Bulletin Number: VF-015
Effective: October 1, 1991

EXTERNAL LEAKAGE: CLAMP SUPPORT MODIFICATION

Affected Models: All VacuFlush® and Traveler® toilets.

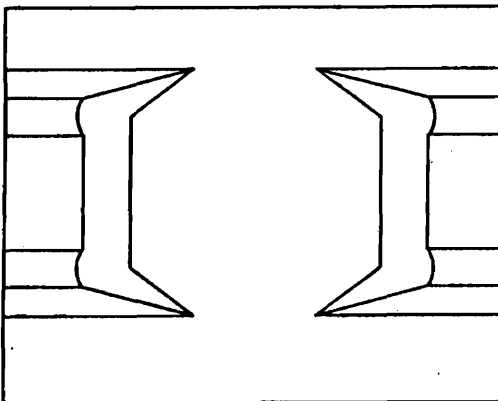
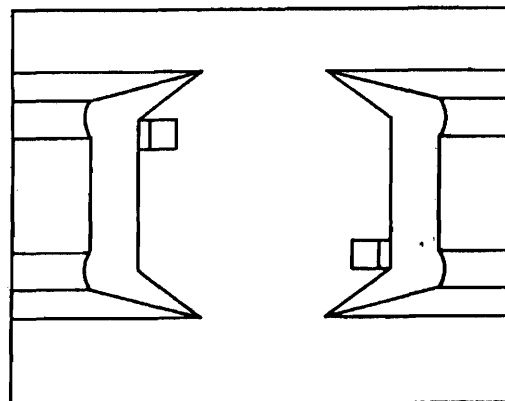
Symptom: Occasionally an external leak of bowl contents occurs in the rear of the toilet base area. Visible inspection of all components reveals no cracking or distortion. Leak occurs while customer is sitting on unit.

Cause: A study of the bowl-to-base seal was conducted to simulate loading in use. It was discovered that excessive front loading (in excess of 250 pounds) on the bowl caused the clamp supports holding the toilet base and bowl together to shift out of position.

Corrective Action: As of October, 1, 1990, all units have been produced with a modified clamp support. This modification consists of a tab molded into the interior surface of the clamp support. The tab is in an offset position so when the two clamp supports are assembled on the toilet, the tabs prevent shifting of the clamp supports during excessive loading conditions on the front of the bowl.
